Dear editor and reviewers,

Response to Reviewer #1

- Title: We removed “sediment transport” from the title, then the title became “Representing the impact of *Rhizophora* mangroves on flow in a hydrodynamic model (COAWST_rh v1.0): the importance of three-dimensional root system structures”.

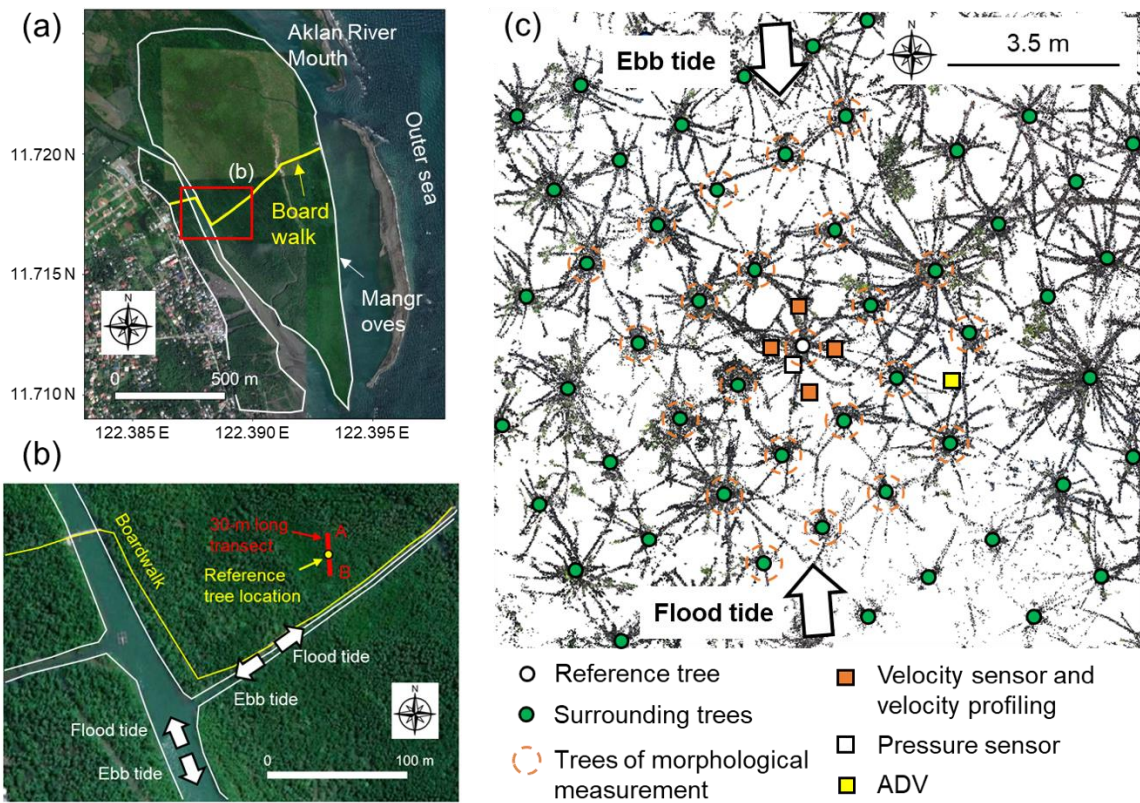
1) To understand where the data comes from I suggest to add maps of both the study area and the model grid with flow velocities as well as the set-up of the flume experiments/model of the flume experiments. It is unclear where the measurements have been taken (unvegetated vs. within the root system, close to tidal channels etc) and how exactly the model looks to allow to understand the results and to reproduce the study. In addition the data used for validation should be presented in the supplementary.

We have provided in Fig. R1 of this document the maps of the field measurement of Yoshikai et al. (2022) used for the model application in this study, and in Fig. R2 the schematic of the model grid used for testing the model against the flume experiment and field measurement. The set-up of the flume experiment has been described in detail in Maza et al. (2017). Because the reuse of the figures in Maza et al. (2017) in this manuscript would cost us a substantial amount of payment to the publisher of the original article, we would like to refer the reviewers and readers to their original article. We have also provided in Tables R1–3 below the data used for model validation. Furthermore, for a better grasp of the measurements of Maza et al. (2017) and Yoshikai et al. (2022) and the model setting, we have provided Table R4 summarizing the measured flow variables, the setting of model forcing, and the target variables to reproduce for each application.

In the revised manuscript, we included Figs. R1–2 and Tables R1–4 in the Supporting Information as Figs. S1–2 and Tables S3–6, respectively. We also included missing descriptions on the model settings explained above in Section 2.2 in the revised manuscript; please see L. 225–233 and L. 242–244 in the marked-up version.

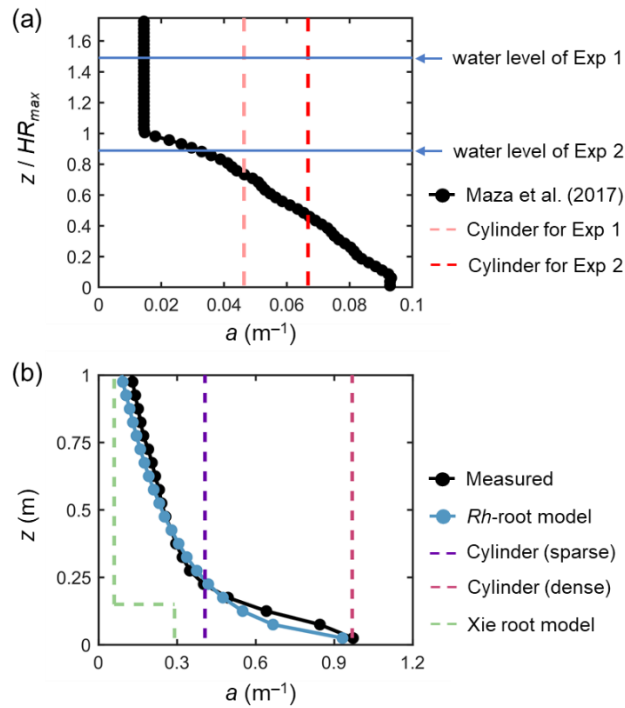
2) I am not sure you need the reference runs in your graphs since you are comparing the new root structures with static vegetation. Why not add the model in Xie et al (2020) to compare with another "more realistic" representation of roots?

Figure R3, which is a revision of Fig. 3 in the original manuscript, shows the vegetation projected area density predicted using the Xie root model applied to the field mangrove forest. The Xie root model predicted the vegetation projected area density near the bed as 0.3 m^{-1} , which is significantly lower than the measured value. In addition, due to the limited root height ($H_{root} = 0.15$ m), it resulted in the significantly underestimated vegetation projected area density (a) throughout the depths.

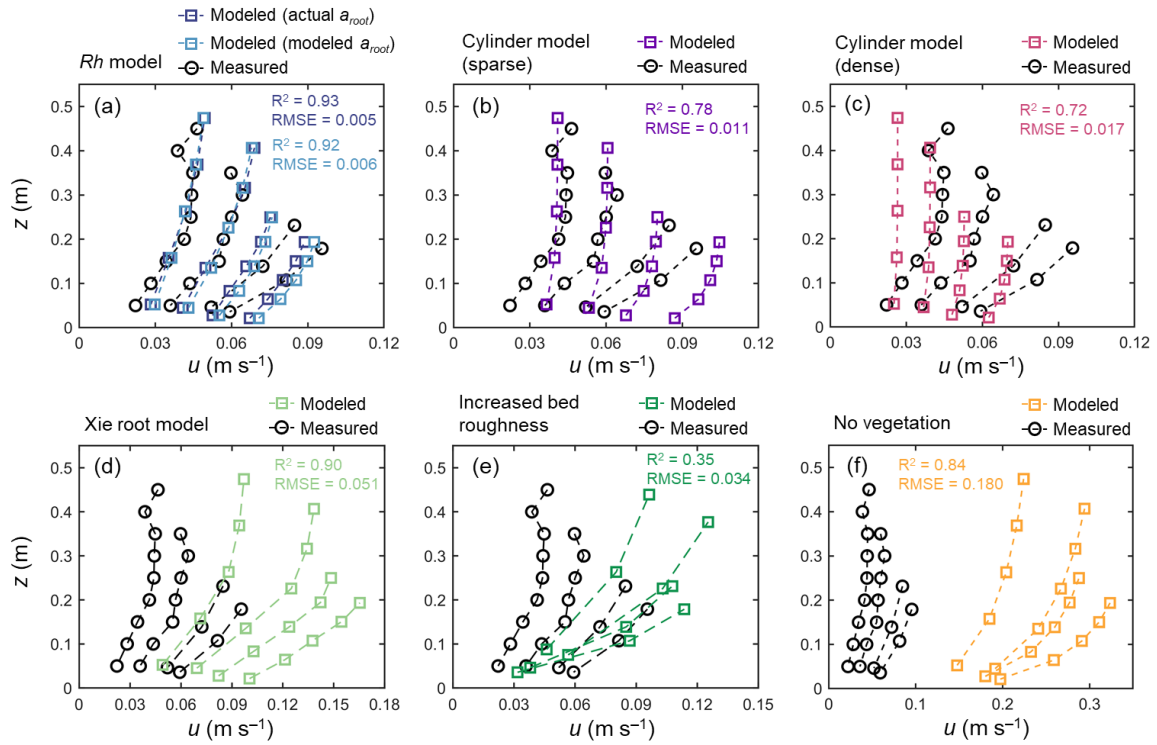
Fig 5: what absolute water levels and time-steps throughout the tidal cycle are presented here? I am not sure what the difference is between actual and modeled aroot. Is one the data and one the predictions of the implemented model? Add R^2 values to quantify the error

A comparison of the modeled velocity profiles with measurements is provided in Fig. R4d, which is a revision of Fig. 5. As expected, the use of Xie root model lead significant overestimation of velocities. Although the shape of a predicted by Xie root model resembles those of submerged vegetations, the predicted velocity profiles did not show a prominent velocity inflection between within and above the canopy layer (root zone in this case), a profile typically observed in the flows in a region with submerged vegetations (e.g., King et al., 2012; Nepf, 2012). This may be due to the low vegetation area density predicted by the Xie root model that was not dense enough to generate the velocity inflection. Nepf (2012) suggested that the velocity profile in a region with submerged vegetations exhibits a boundary-layer form with no inflection point if $C_D a h_v < 0.04$ (where h_v is the height of vegetation). Considering the similar factor for the root zone ($C_D a H_{root}$) in our analysis and

Finally, we have added R^2 and RMSE values in the figure. Please see Fig. R4 shown above or Fig. 5 in the revised manuscript.

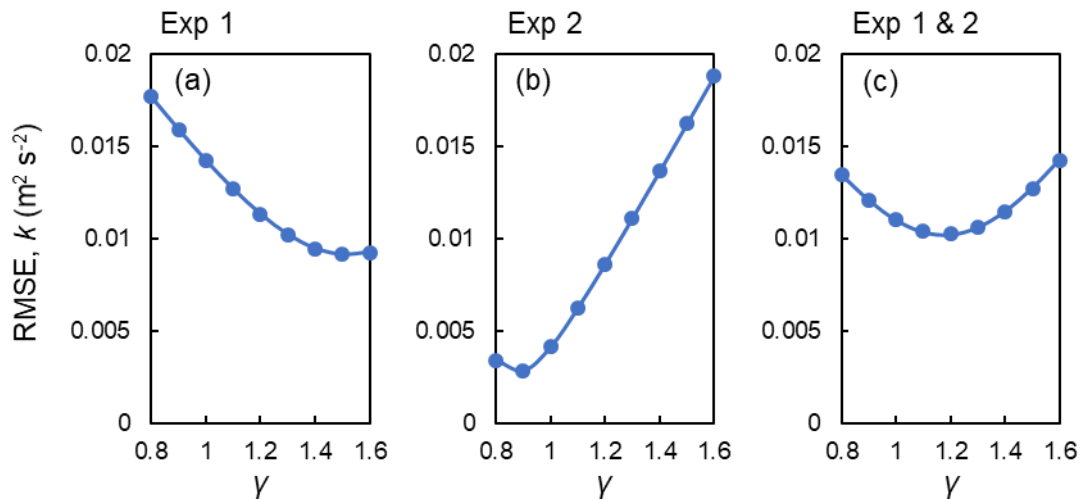
line 259: please present the sensitivity runs in the supplementary

We provided the results of sensitivity runs of varying γ in the prediction of the vertical profile of turbulent kinetic energy in Fig. S6. We included Fig. S6 in the Supporting Information as Fig. S3.

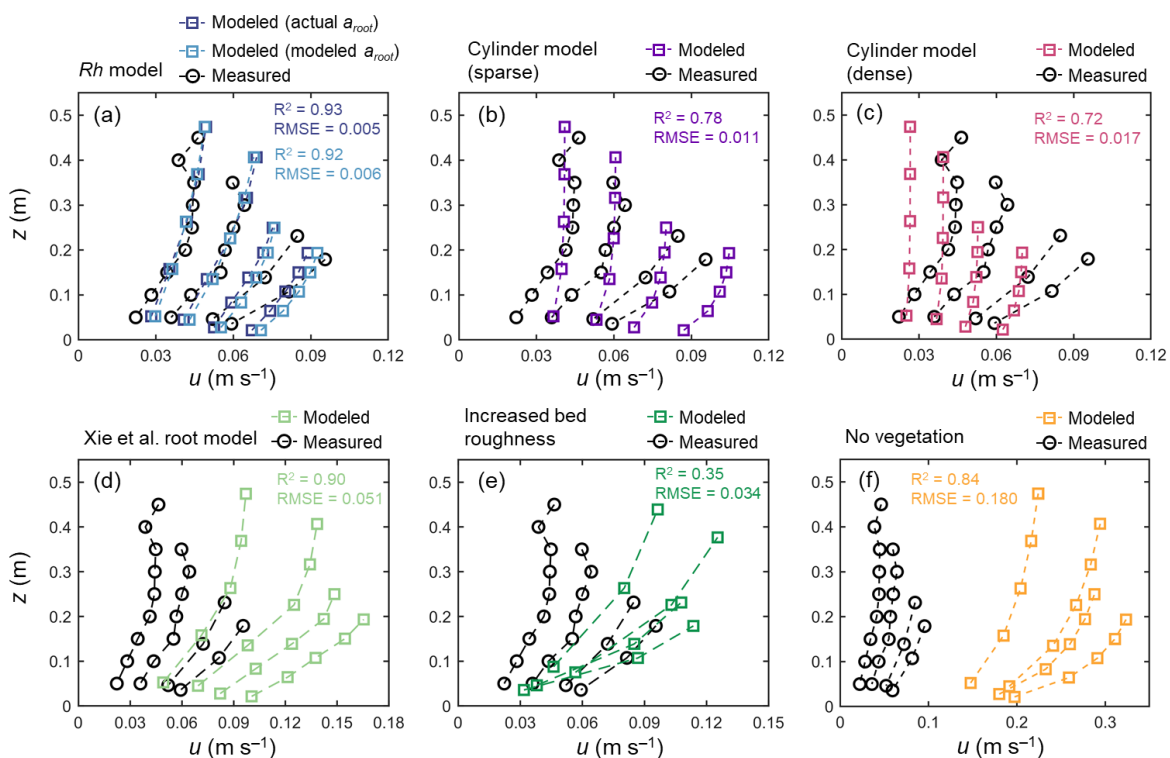
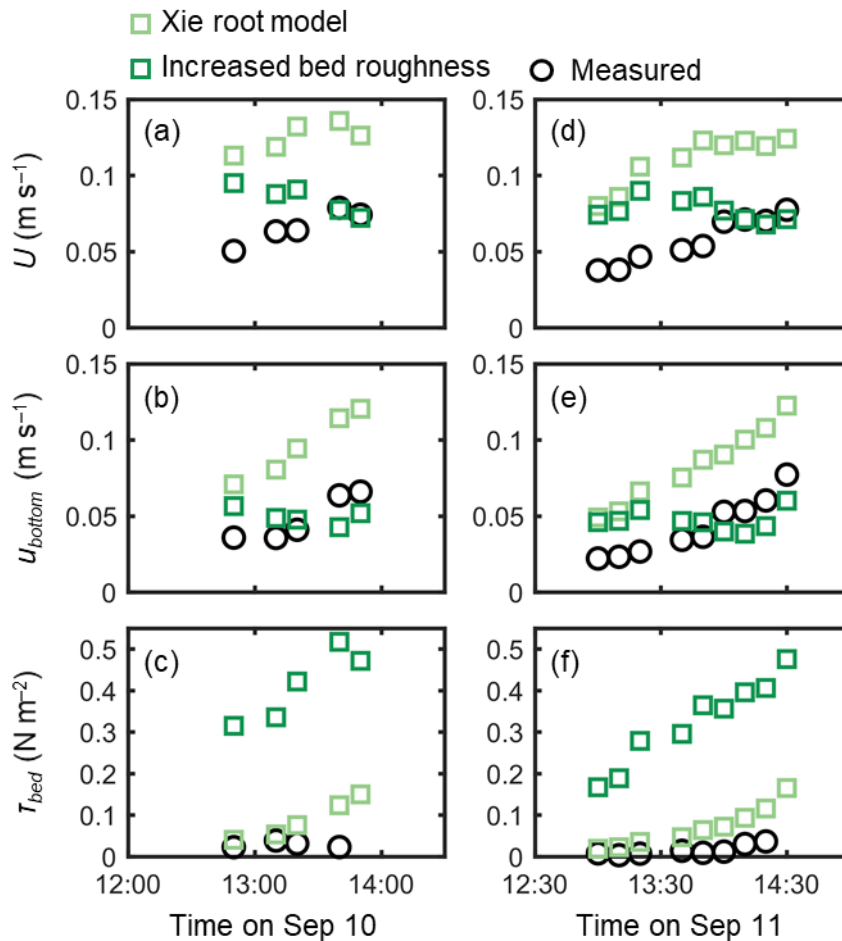
1. The no vegetation case shown in Fig. 5 and Fig S1.
 1. While including this test case in the manuscript is interesting to see how the hydrodynamics are changed if the mangroves were removed from the ecosystem, it seems to change direction from the rest of the paper. I believe the message of this paper is comparing how this new approach of accounting for the roughness of mangroves is different from past approaches (cylinder arrays or enhanced z_0 values). I think that if the z_0 value for the no-vegetation case is increased, maybe similarly to the Zhang 2012 mentioned on line 65, this would fit with the theme of figures 5 and 6 which contrast the new approach to past approaches.

Results of the model analysis with the increased z_0 are provided in Figs. R4e and R5 (Figs. 5e and 8 in the revised manuscript), which can be seen below. The model predicted the significant attenuation of flow velocity from the surface to the bottom due to the large bottom friction produced by the increased z_0 , which did not well represent the actual conditions of the velocity profile in the *Rhizophora* mangrove forest (Fig. R4e).

Comparison with the time-series data showed contrasting results with the one using the Xie root model (please see Response [1.7] for the descriptions of the case using Xie root model). Although both cases showed a large overestimation of flow velocity when the water depth is relatively high (e.g., $h > 0.3$ m), the predicted U in the case using the increased z_0 approached the measured data with decreasing water depth while the case using the Xie root model consistently overestimated the U throughout the measurement period (Fig. R5a–e). This different trend is due to the different drag parameterization with the bed roughness or objects within the water column. Specifically, the decrease in the total projected area of submerged part of the objects exerting drag with a decrease in water depth cannot be accounted for by the mangrove drag approximation with the bed drag. As a consequence, the bed drag became significant in decelerating the flow velocity when the water depth is low ($h < 0.3$ m) compared to the case using the Xie root model, as seen in the equivalent U to the measured values (Fig. R5a, d). Because bed drag is the main force to counteract the imposed pressure gradient in the increased z_0 case, the bed drag showed the overestimation as expected (Fig. R5c, f). This will lead to large overestimation of sediment erosion, suggesting that increased bed roughness does not work well for simulating the sediment transport in mangrove forests.

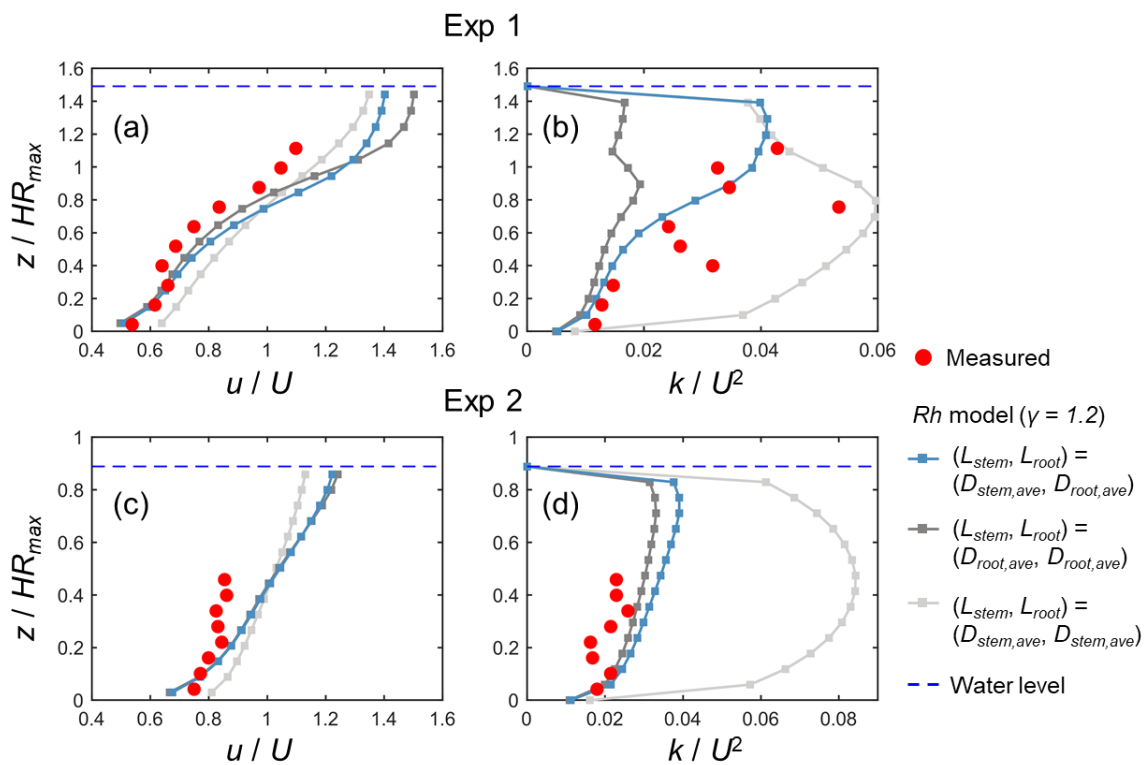
3. I would love to see a figure that shows the difference accounting for 2 length-scales in the turbulence routines makes. This is mentioned on lines 444-445 and lines 424-426. I haven't seen a figure that does this yet, and the changes to the code are already made so I think this could be a nice addition to the paper.

As suggested by the reviewer, we have examined the effects of accounting for the different length-scales of stem- and root-generated wakes in the presented model (*Rh* model). We have done it by performing additional model analyses for the flume experiments that set the two length-scales to either the root diameter ($D_{root,ave}$) or the stem diameter ($D_{stem,ave}$).

The results clearly showed that without accounting for the two different length-scales, the model fails to predict the vertical profile of turbulent kinetic energy (k) (Fig. R7). If the two length-scales are set to the stem diameter, the model largely overestimates k specifically in the root zone ($z/HR_{max} < 1$), whereas the model with the length-scales set to the root diameter largely underestimated k in the upper and above the root zone ($z/HR_{max} > 0.5$). The model that has the length-scales set to the root diameter showed a slight increase in k at the height around $z/HR_{max} = 0.9$ (Fig. R7b), possibly due to the velocity shear generated by the sharp decrease in frontal area at the top of the root zone (Maza et al., 2017; Fig. 3a). However, this increase in k alone is not enough to explain the significantly higher k at upper and above the root zone compared to the lower root zone, suggesting the significant roles of the different length-scales of stem- and root-generated wakes in shaping the overall structure of k .

“Without accounting for the two different length-scales, the model failed to reproduce the TKE profile while the velocity profile remained similar, suggesting the minor importance of shear production for reproducing the TKE (Fig. S5).”
